DETERMINATION OF NON-SIGNIFICANCE

LOCATION OF PROPOSAL: 16199 Northup Way

FILE NUMBER: 09-108130-LB

Proposal Title: Eastside Torah Center

East Elevation (main entrance)

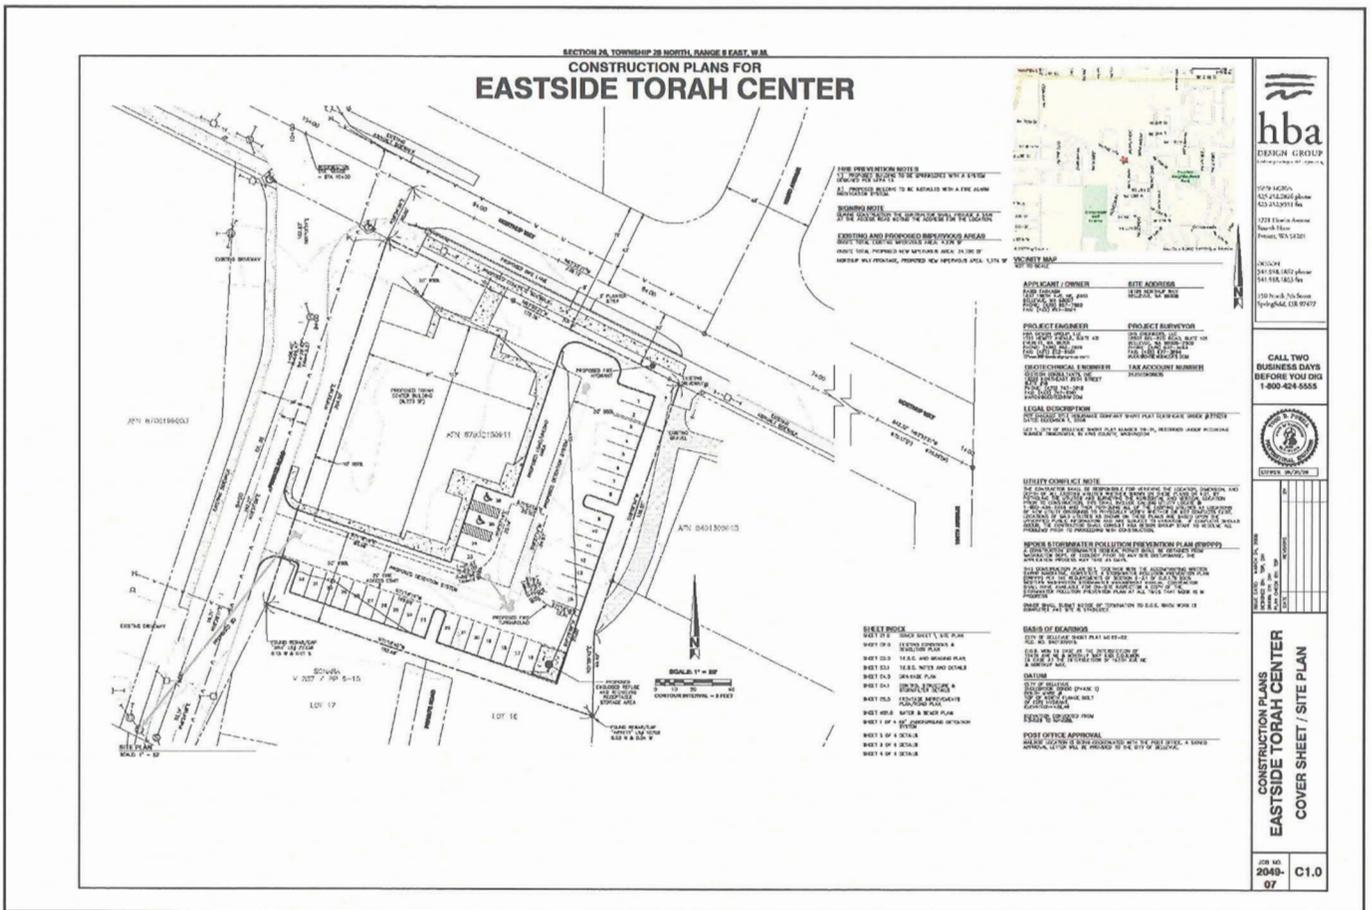
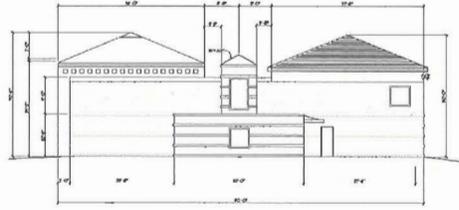
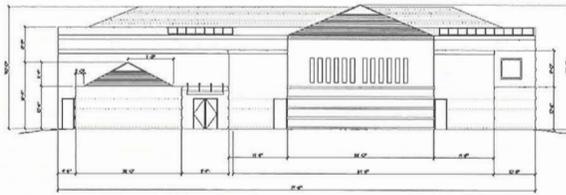
Finding: The proposed architecture is of a “residential” scale and designed for compatibility with the surrounding single family homes. The massing and pitched roof forms provide architectural interest. To provide more architectural interest to the horizontal stripes at the base, the applicant shall provide vertical lines. See condition XI.C.2.

In order to provide additional architectural interest, the applicant shall provide vertical lines to break up the height of the horizontal stripes. This shall be shown on the building permit plans prior to issuance.

Street Frontage Improvements

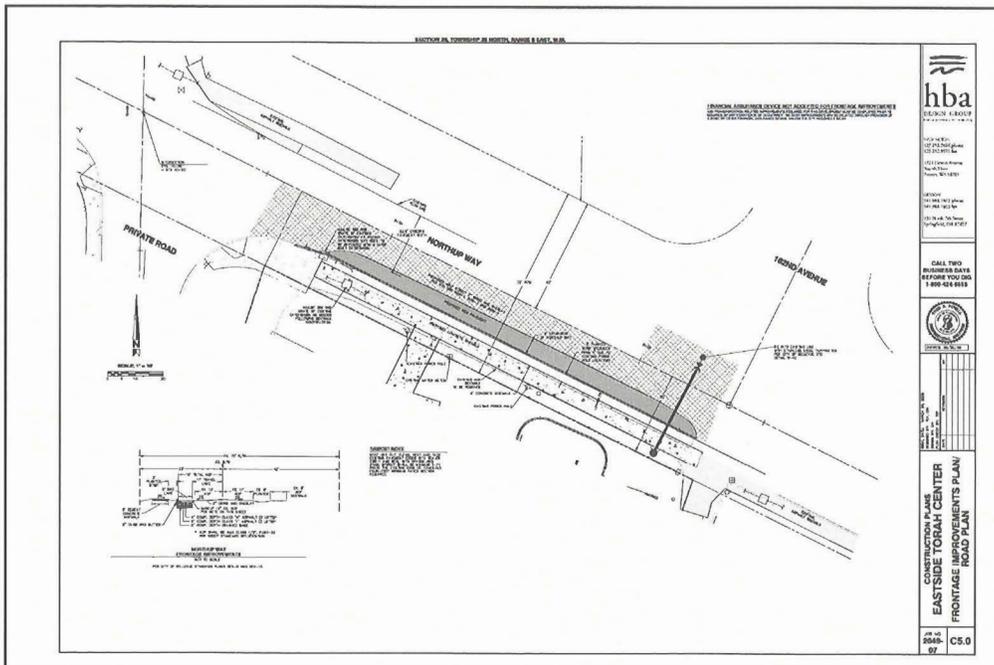
- 8) The paved width on Northup Way must be widened to provide the minimum 5 feet paved width of a bike lane. The cross section will match the existing pavement width adjacent to the site frontage.

- 9) Curb, gutter, 6 feet wide concrete sidewalk and 4 feet wide planter strip are required on Northup Way. The new concrete sidewalk on the property frontage on Northup Way will end in an ADA compliant transition connection that ends at the existing driveway located at the east side of the property which serves the adjacent lot to the east. Sign notifying that the exiting driveway on Northup Way will not be used as an access to the Eastside Torah Center is required to be installed.

- 11) The ramp at the southeast corner of the intersection of Northup Way and the private road must be made ADA compliant.
- 12) Any pavement disturbance on Northup Way will require overlay type of pavement restoration. The information must be shown on the plans. The developer must have an agreement with the owner of the private road regarding the pavement restoration of the private road.
